Request For Information - 146

The Cora Apartments (19 W Harrison)

Subject:	**Trench Drain and Wall Location at OH Door 209A**	**Status:**	**Open**
Drawing #:	4/A0412	**Spec Sect #:**	
Addendum:		**Submittal #:**

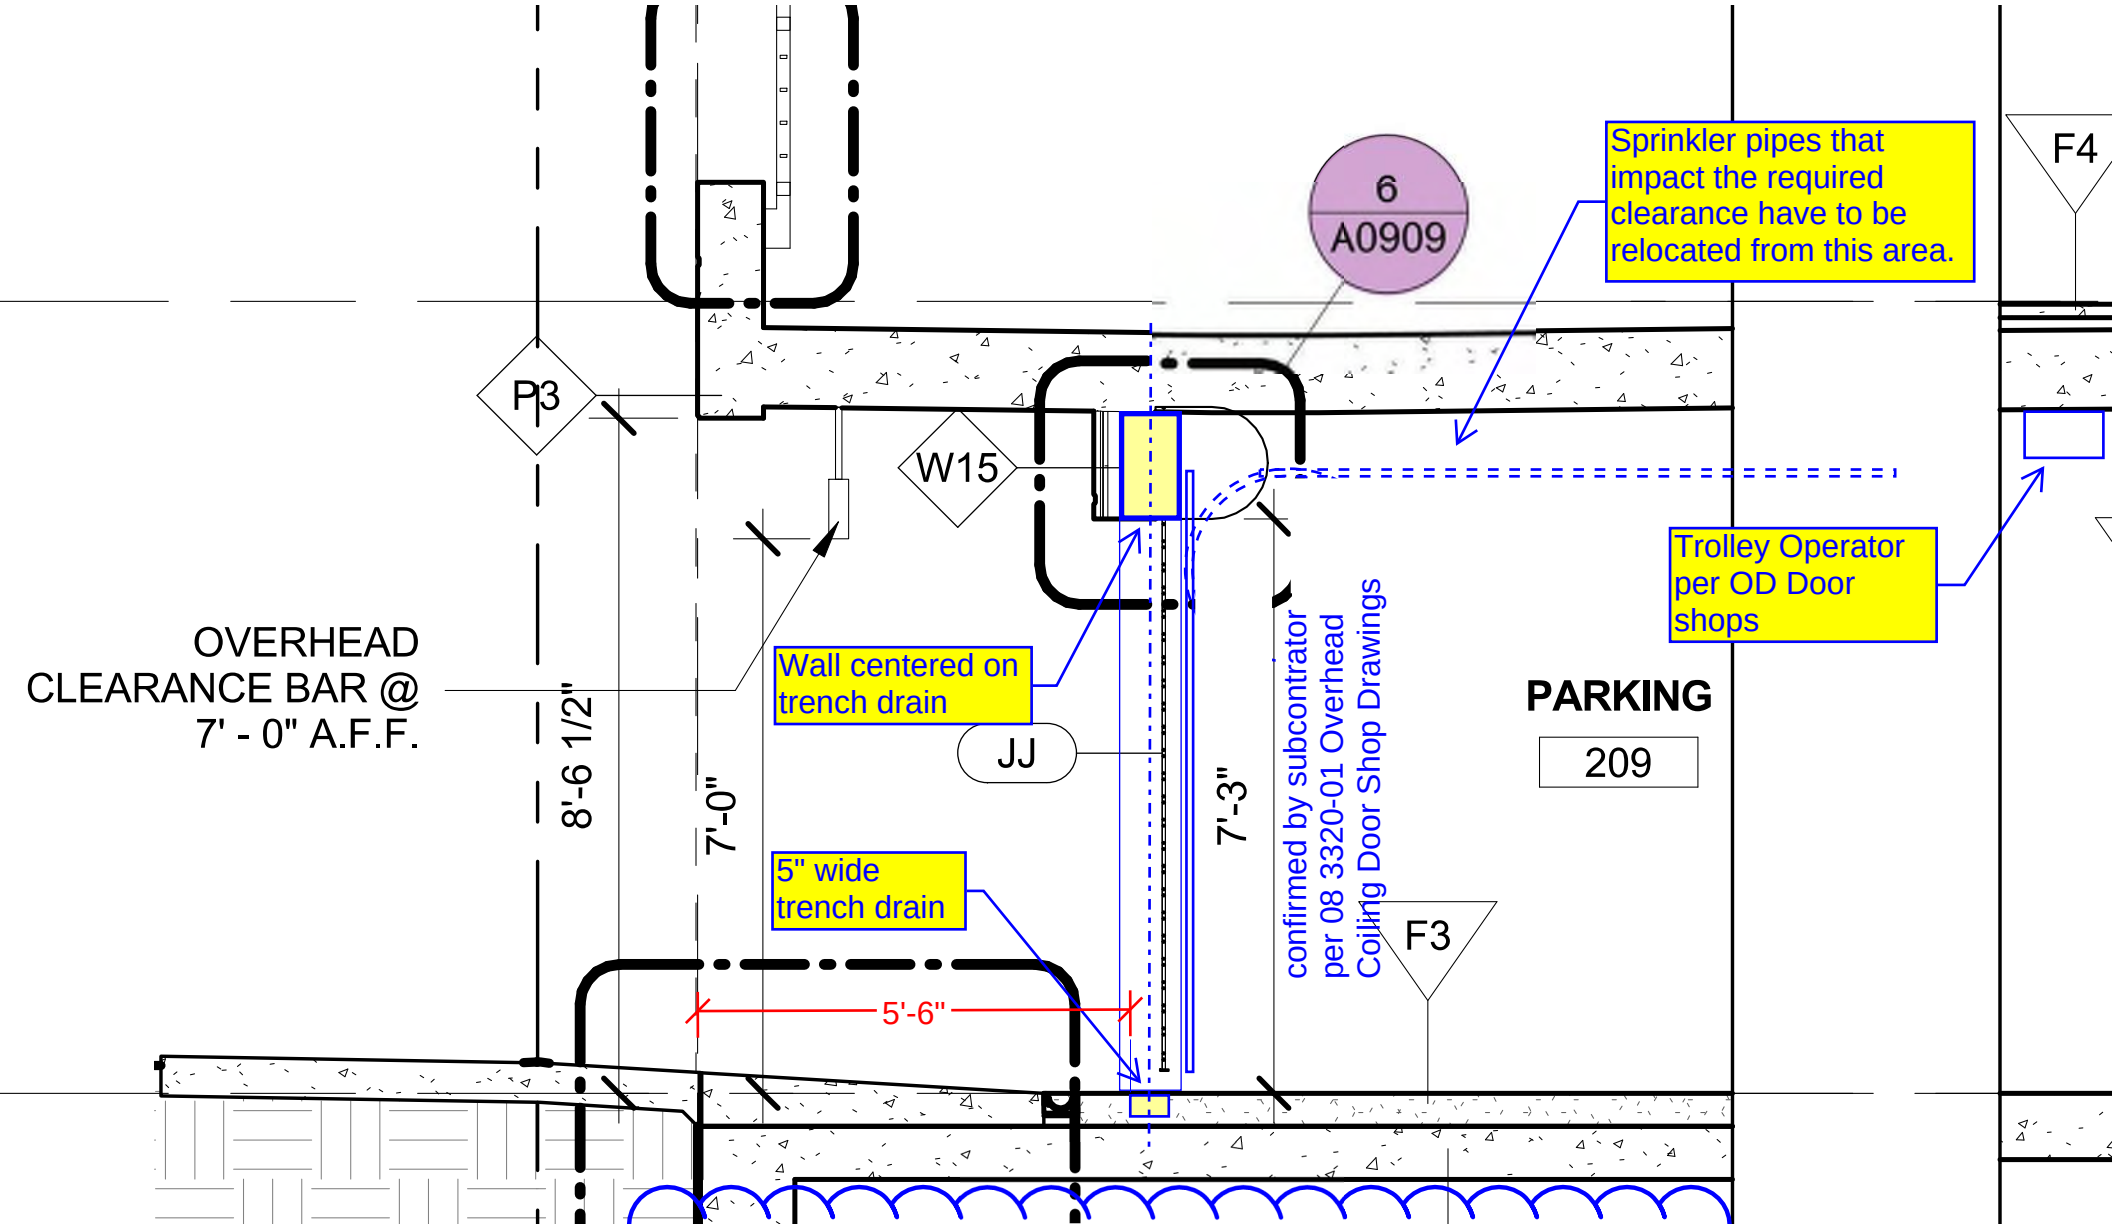
Please confirm if the metal framed wall at the OH door 209A & door 209B should be centered on the joint between concrete and sheetrock. Provide any waterproofing details if neccessay. Also, confirm the 5'-6" distance from the edge of the wall (grid F) to the the leading edge of the trench drain, per onsite review with John W., John L. and Tim C. is acceptable. Please note that any sprinkler pipes that impact the required clearance for the garage door have to be re-routed to allow for the 7'-3" tall door. See the attached sketches.

6
A0909
Sprinkler pipes that impact the required clearance have to be relocated from this area.
F4
P3
W15
Trolley Operator per OD Door shops
OVERHEAD CLEARANCE BAR @ 7' - 0" A.F.F.
Wall centered on trench drain
JJ
8'-6 1/2"
7'-0"
7'-3"
confirmed by subcontrator per 08 3320-01 Overhead Coiling Door Shop Drawings
PARKING
209
5" wide trench drain
F3
5'-6"

NO
TRESPASSING
1'-1"
6"
trench drain

Date	Response
5-15-2017	Modification to the Ramp, Wall and Trench Drain location are acceptable as shown. Verify wall location as noted in Green notes on attached images. JXW

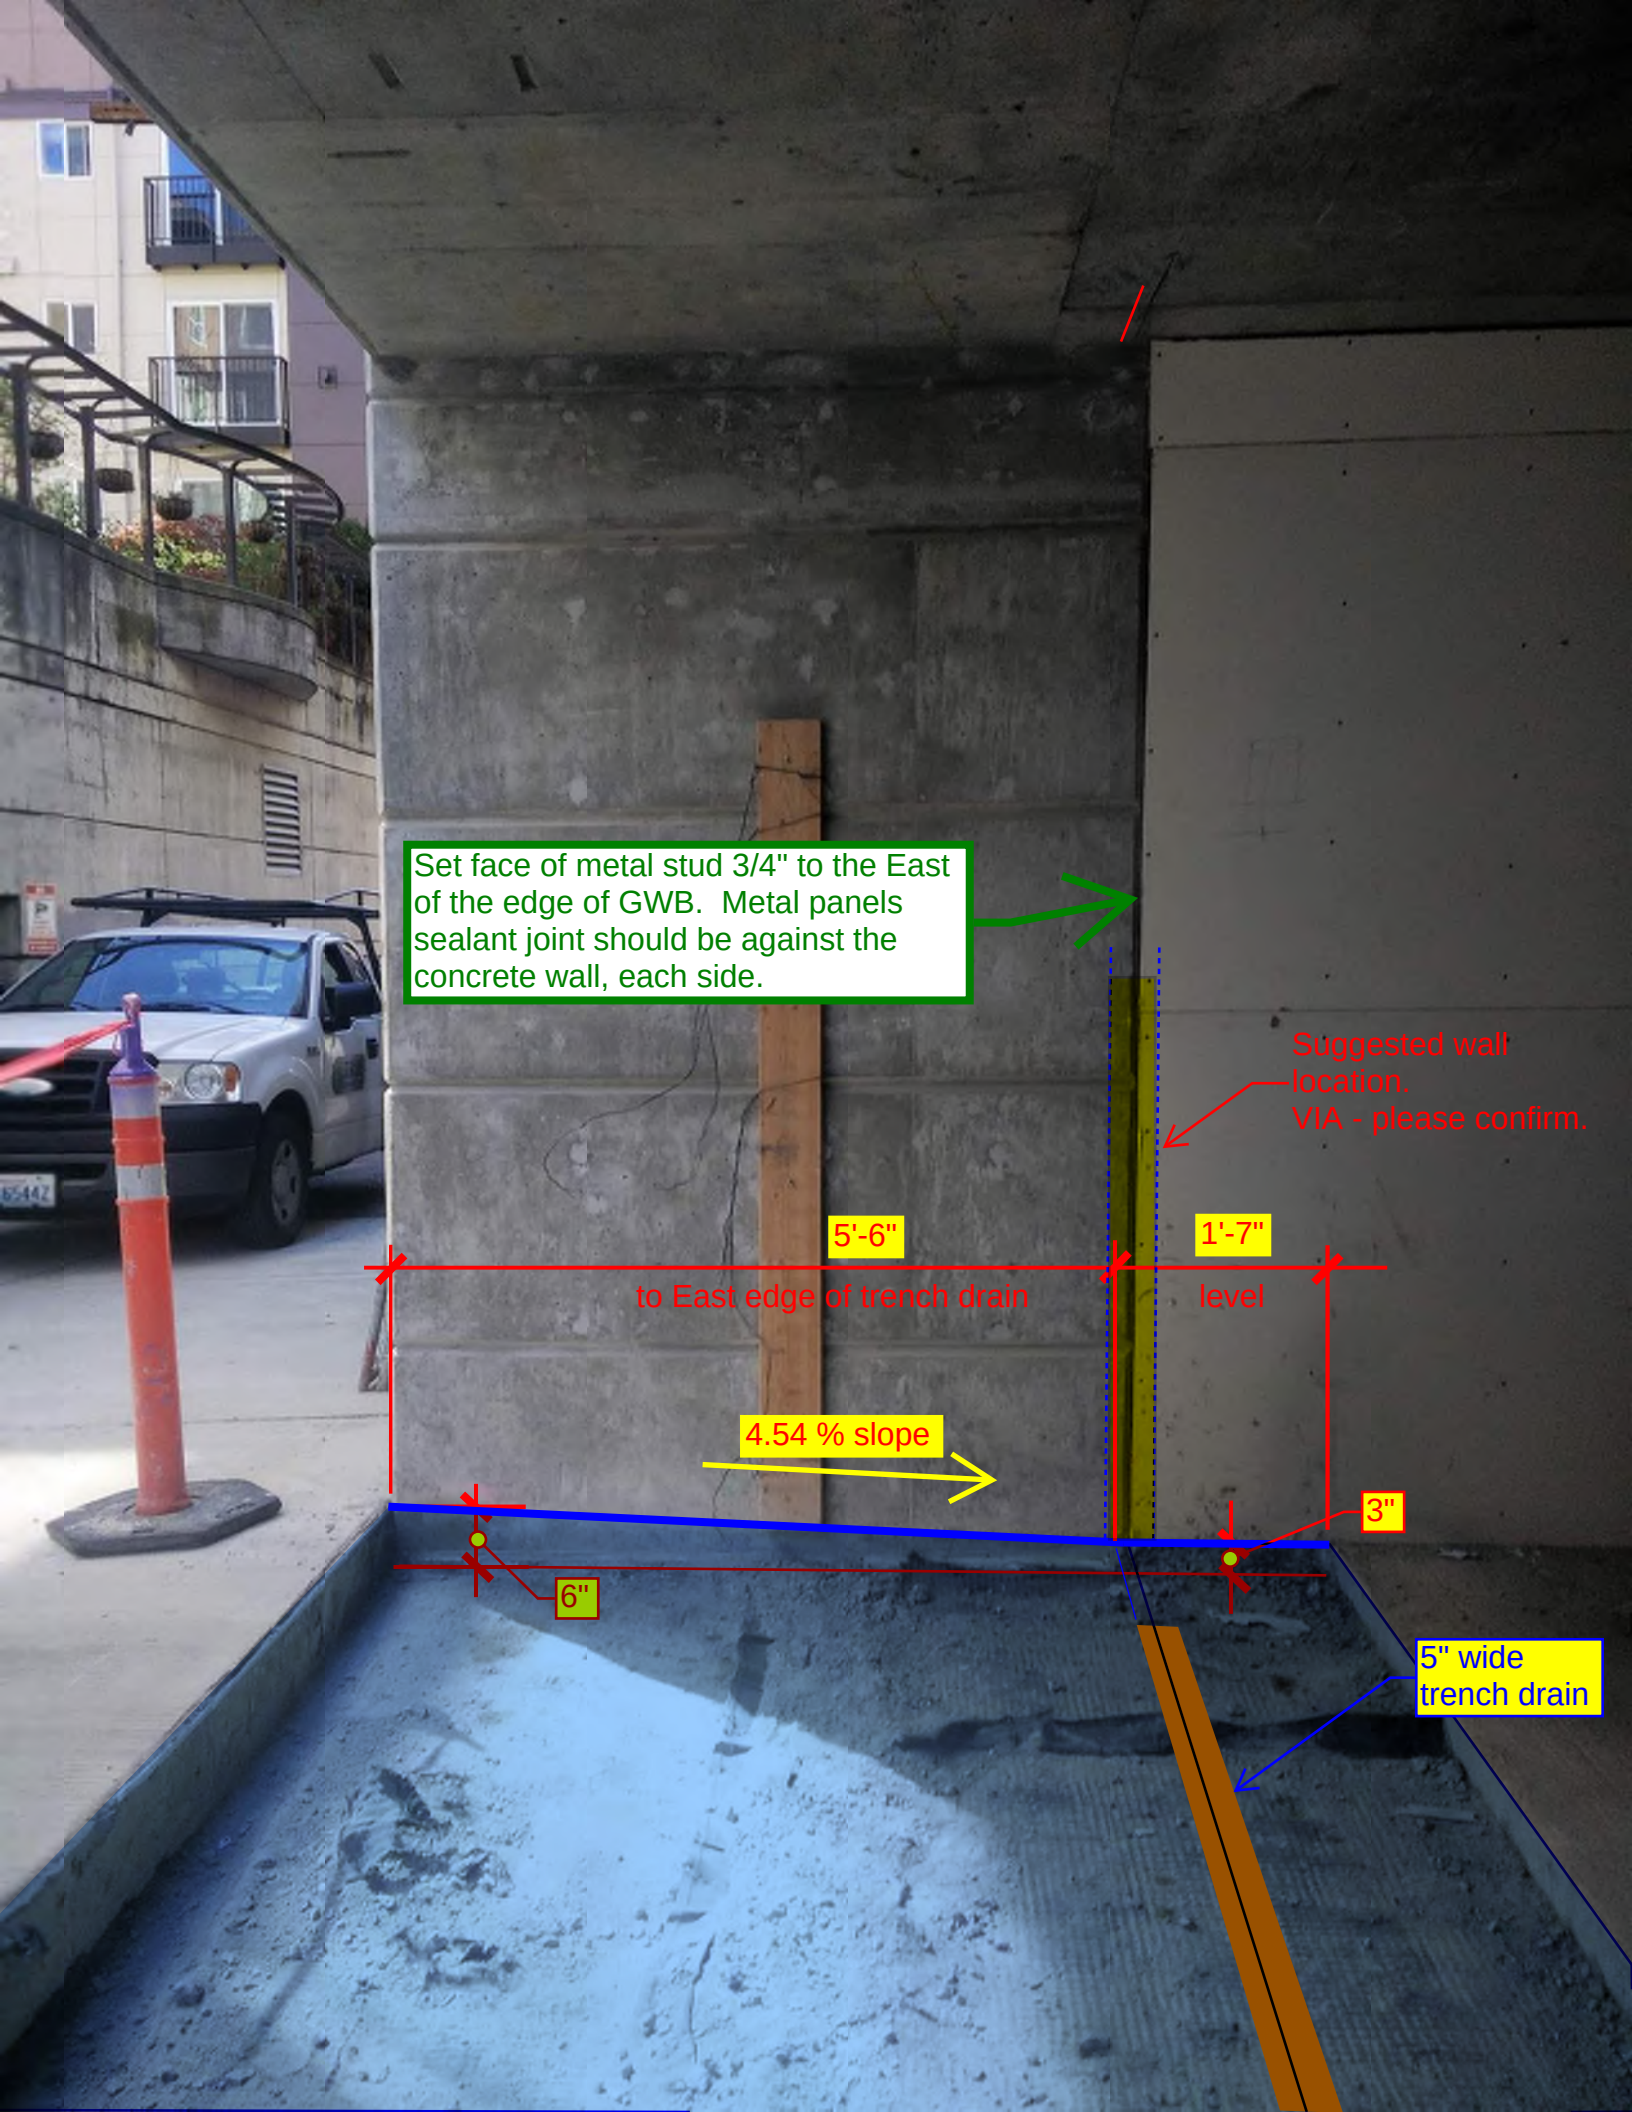
Set face of metal stud 3/4" to the East of the edge of GWB. Metal panels sealant joint should be against the concrete wall, each side.
Suggested wall location.
VIA - please confirm.
5'-6"
to East edge of trench drain
1'-7"
level
4.54 % slope
3"
6"
5" wide trench drain

Verify the wall location will engage the concrete wall on the North side, by min. of 2"
ROAD CLOSED
7'-1"
1'-7"
5'-6"
level
to East edge of trench drain
15.15 % slope
1'-1"
3"
5" wide trench drain
